ADDENDA: 01

Moore Station Expansion

Project Name: Moore Station Expansion Addendum 01
Addendum Date: August 8, 2022

S6

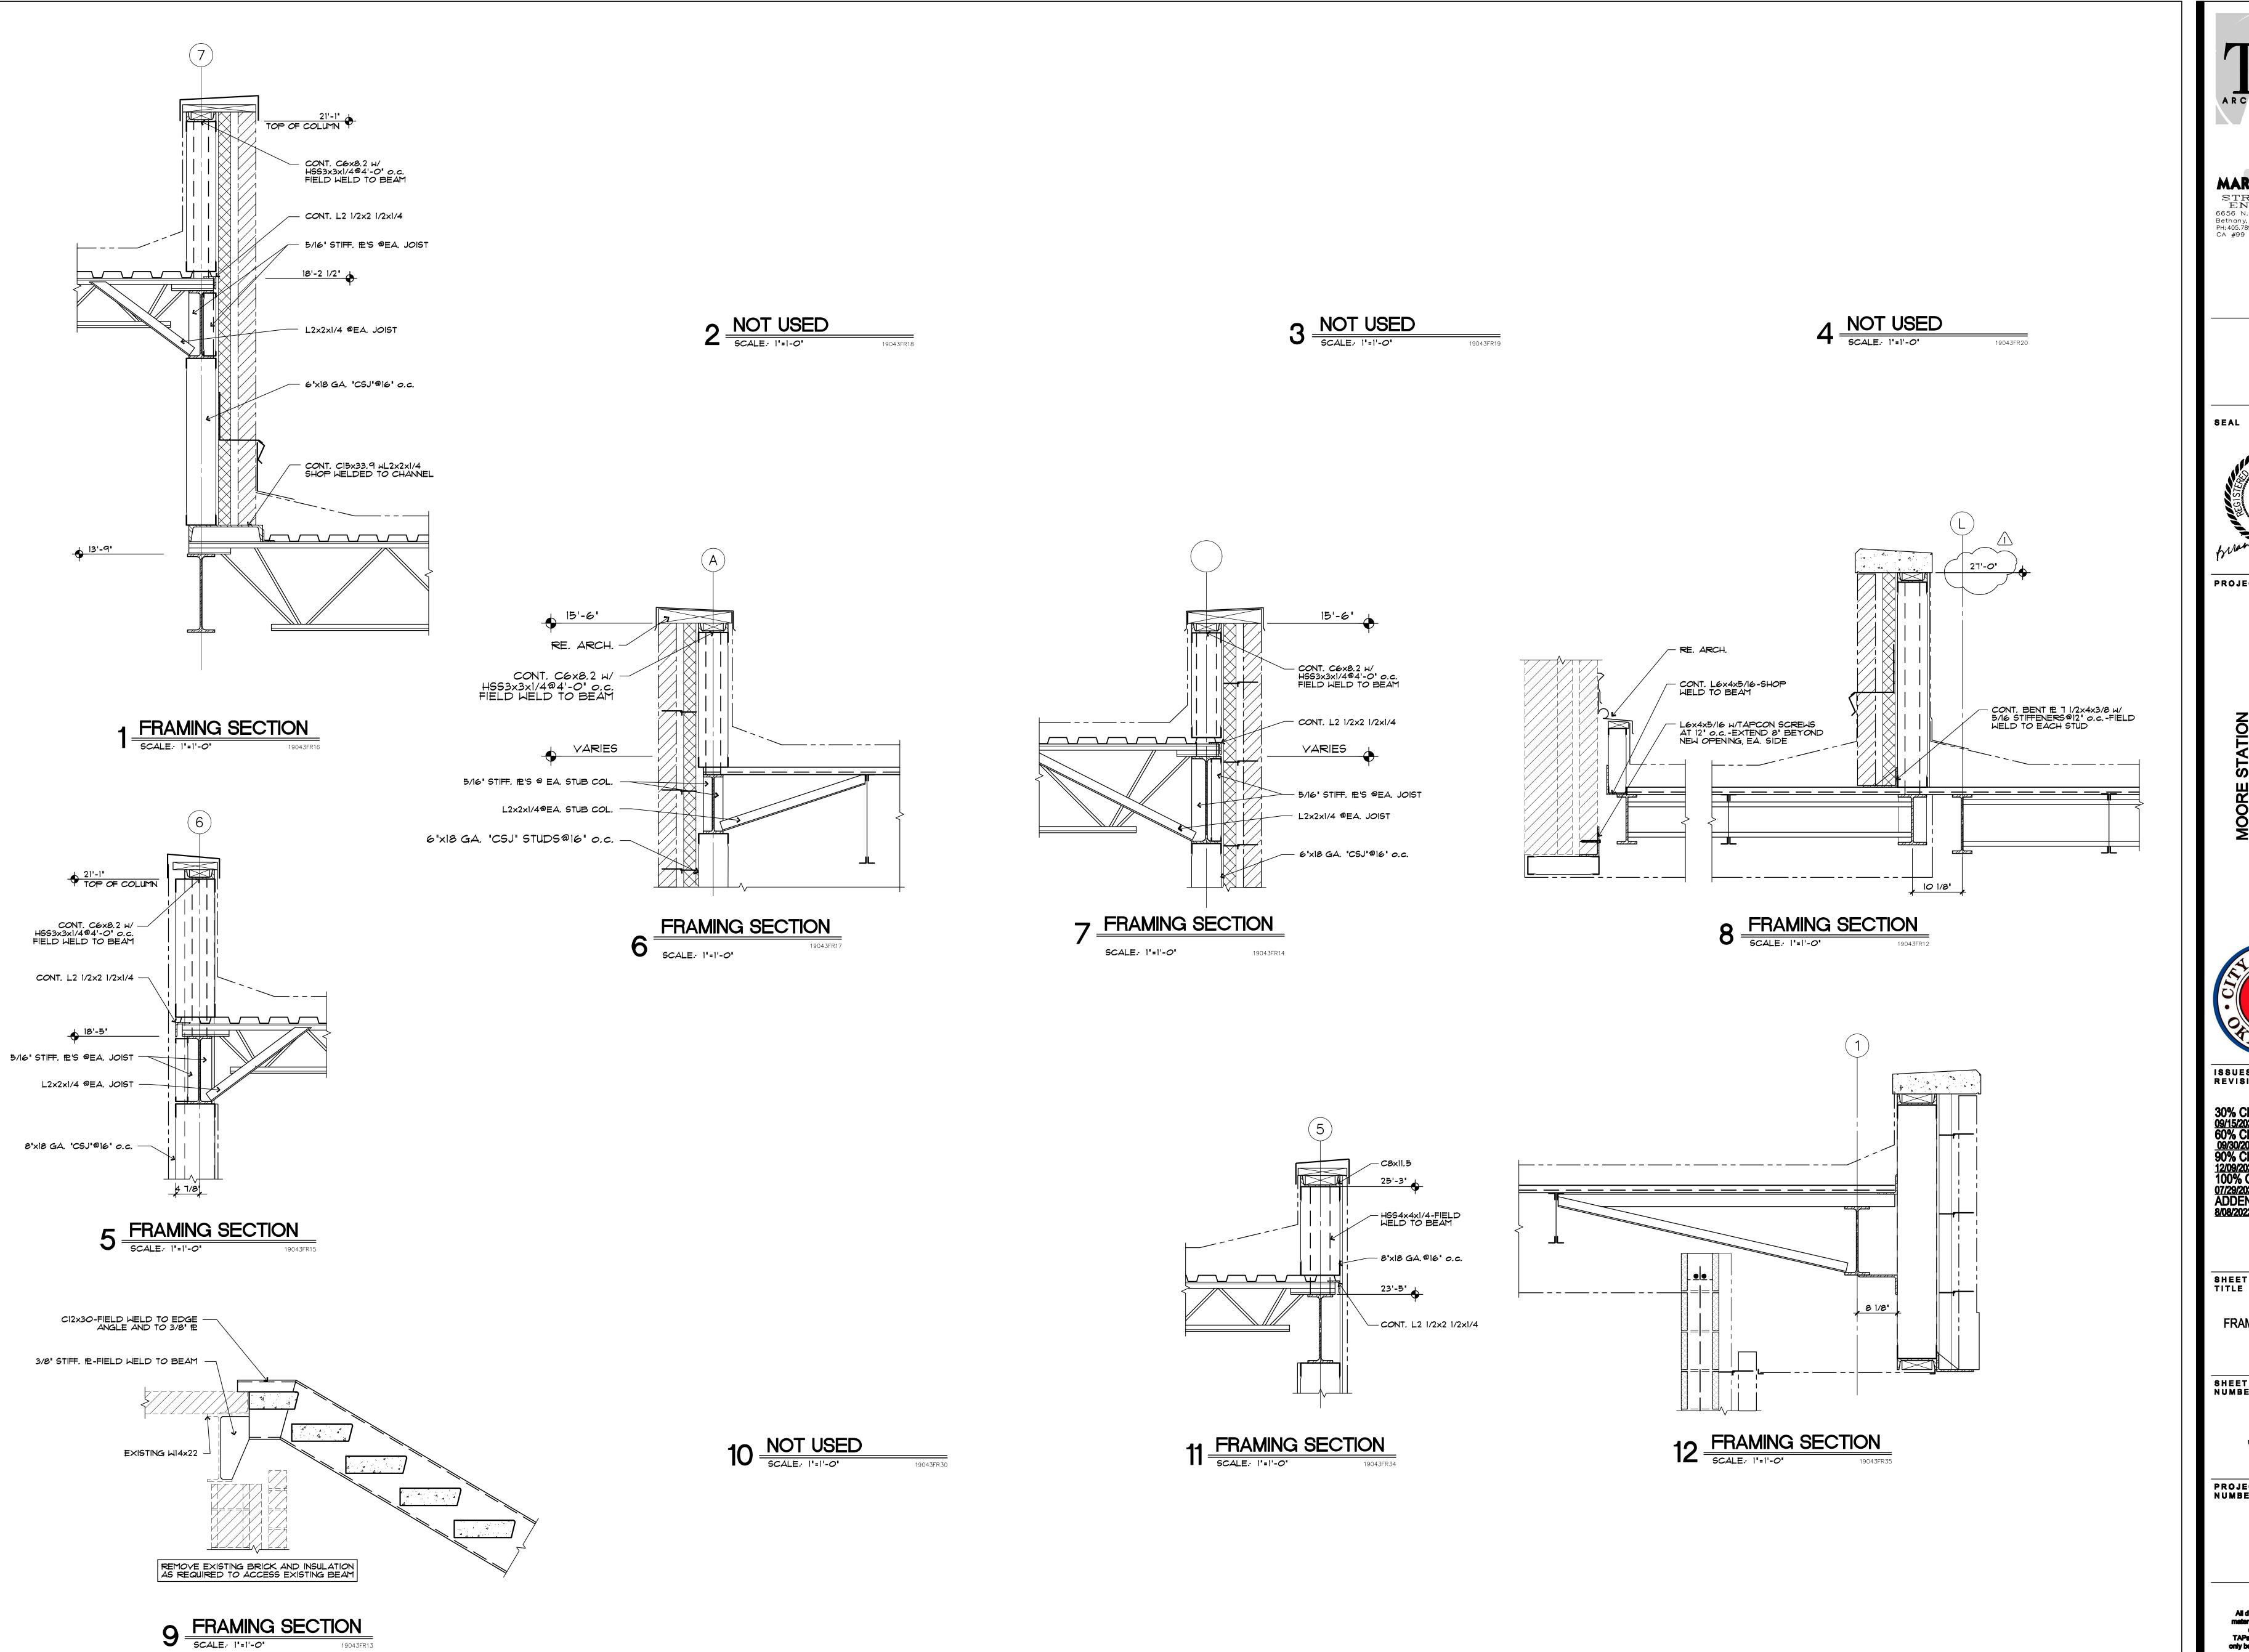
A1.6.5: Refer to \$6 – Detail 1: Revised top of channel elevation.

S7

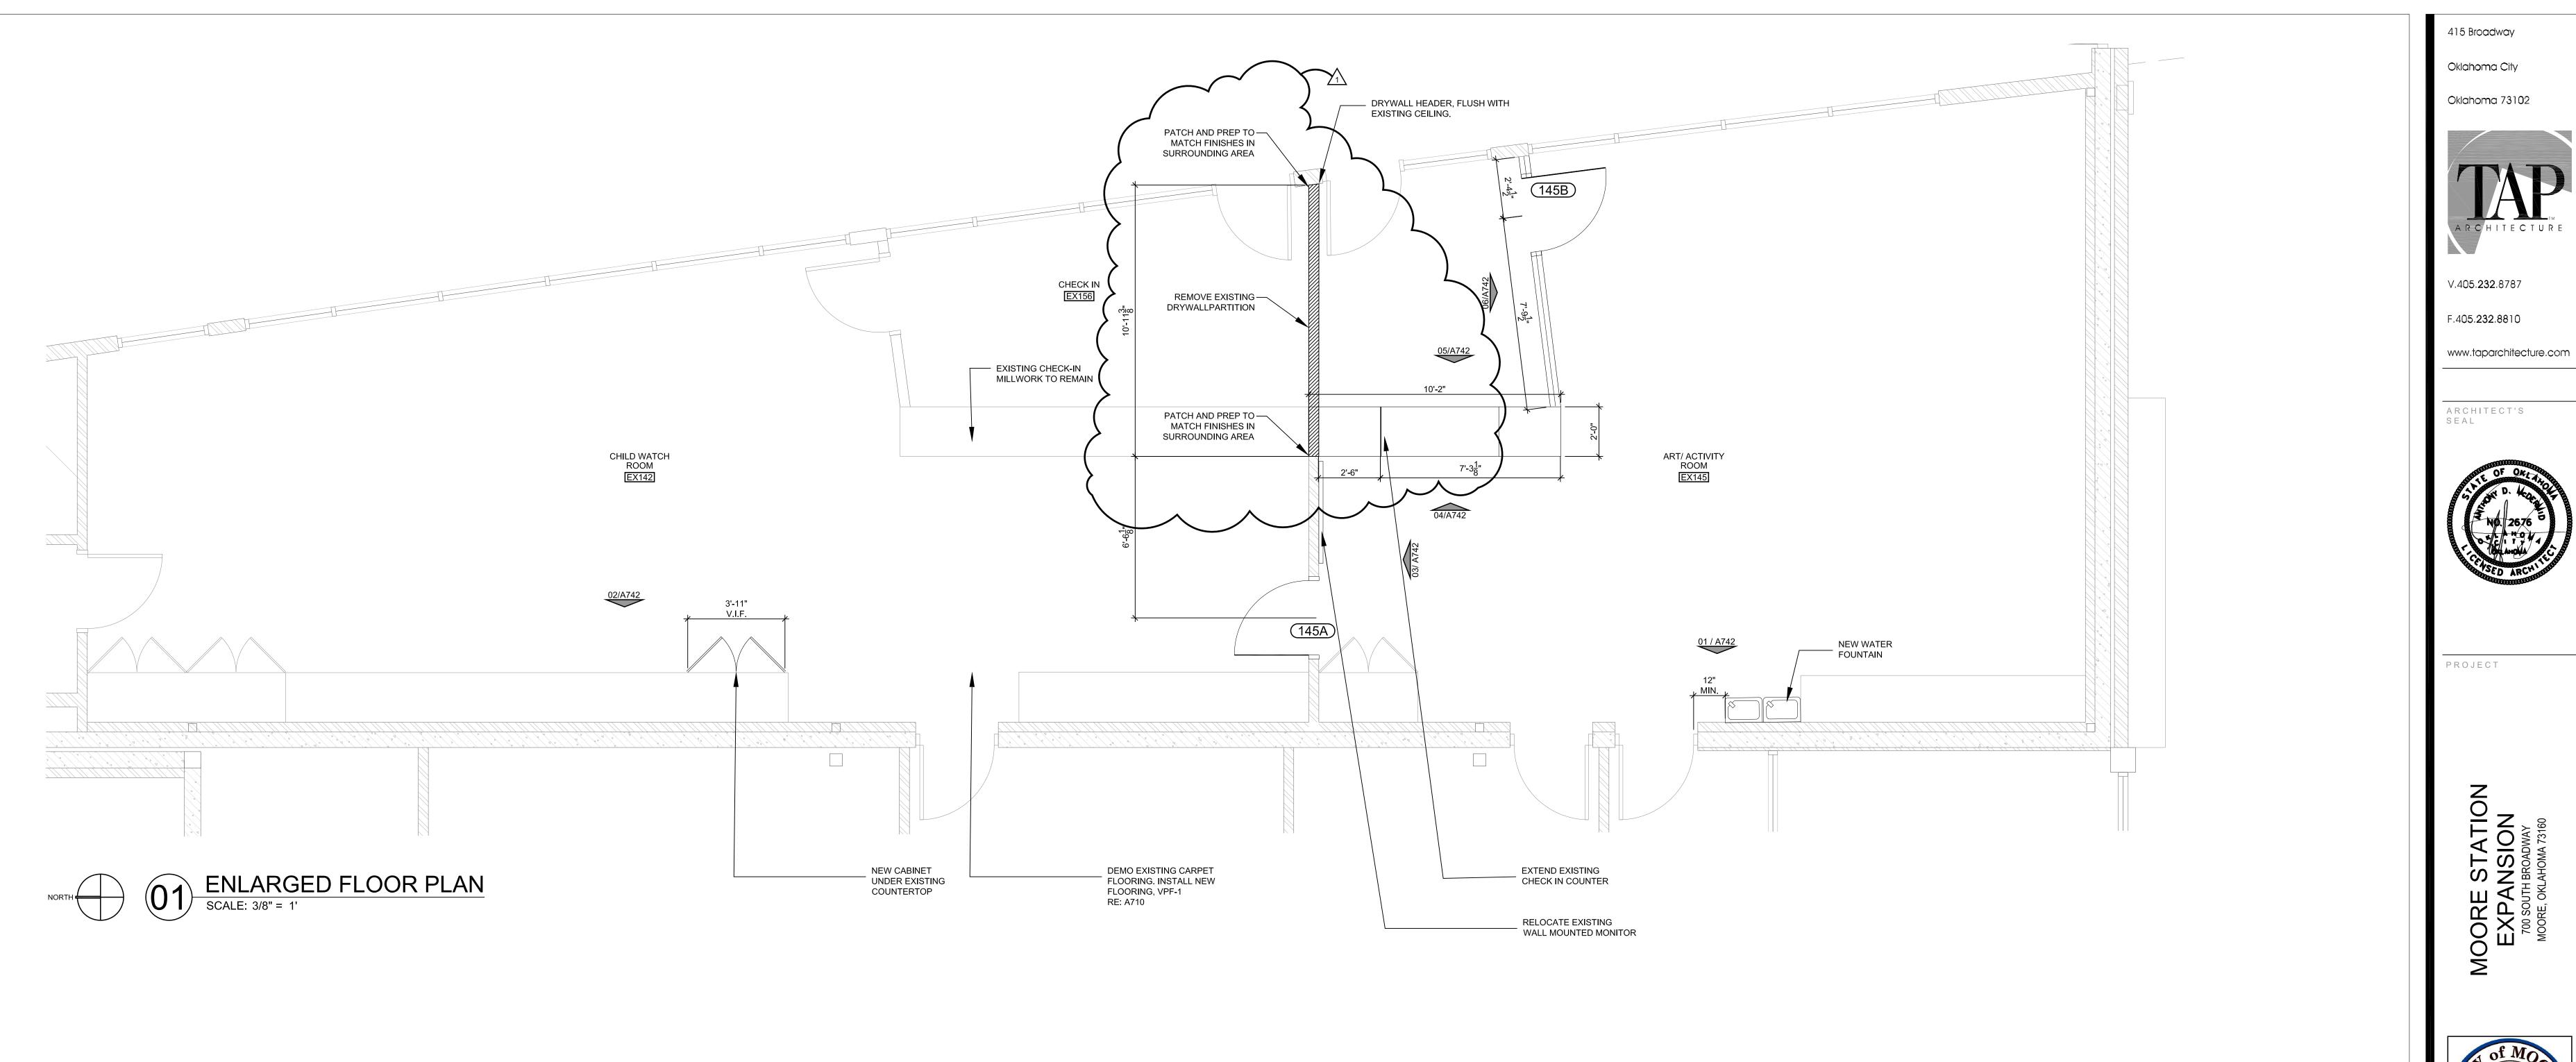
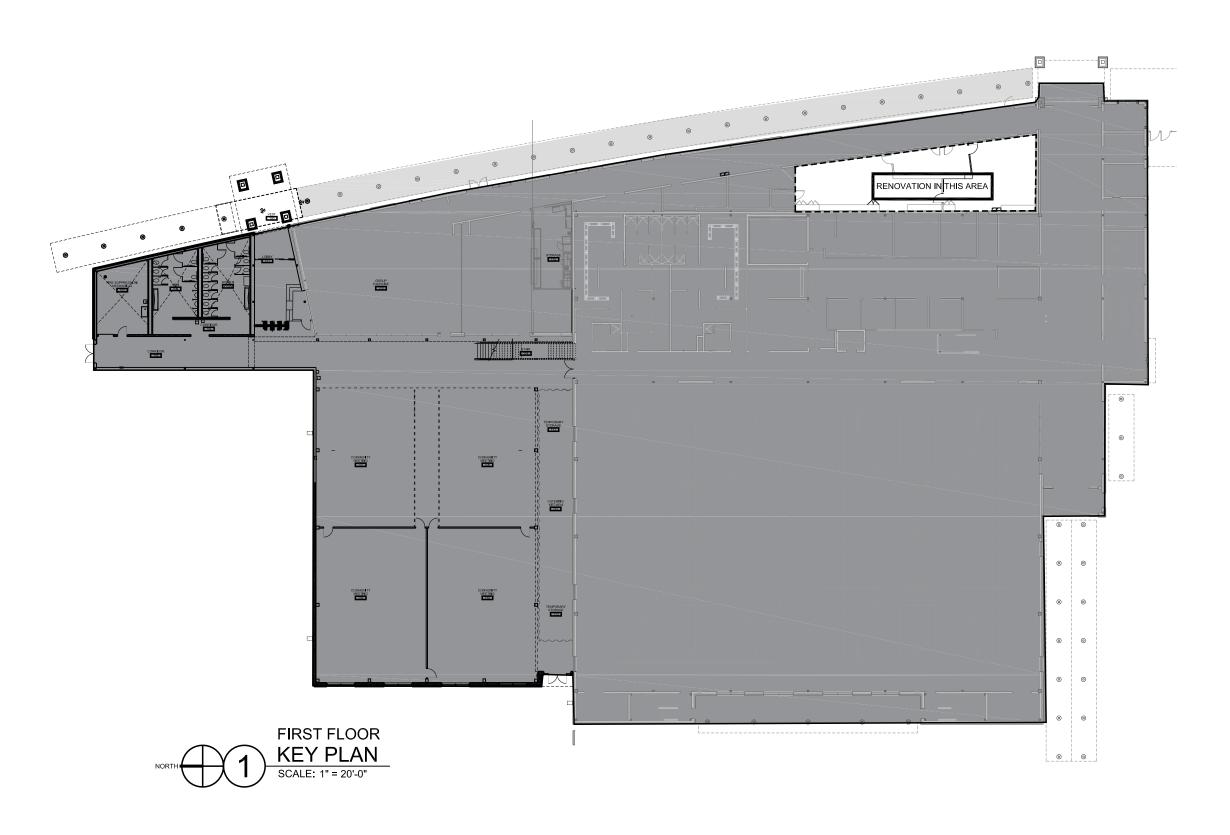
A1.6.6: Refer to S7 – Detail 8: Revised top of channel elevation.
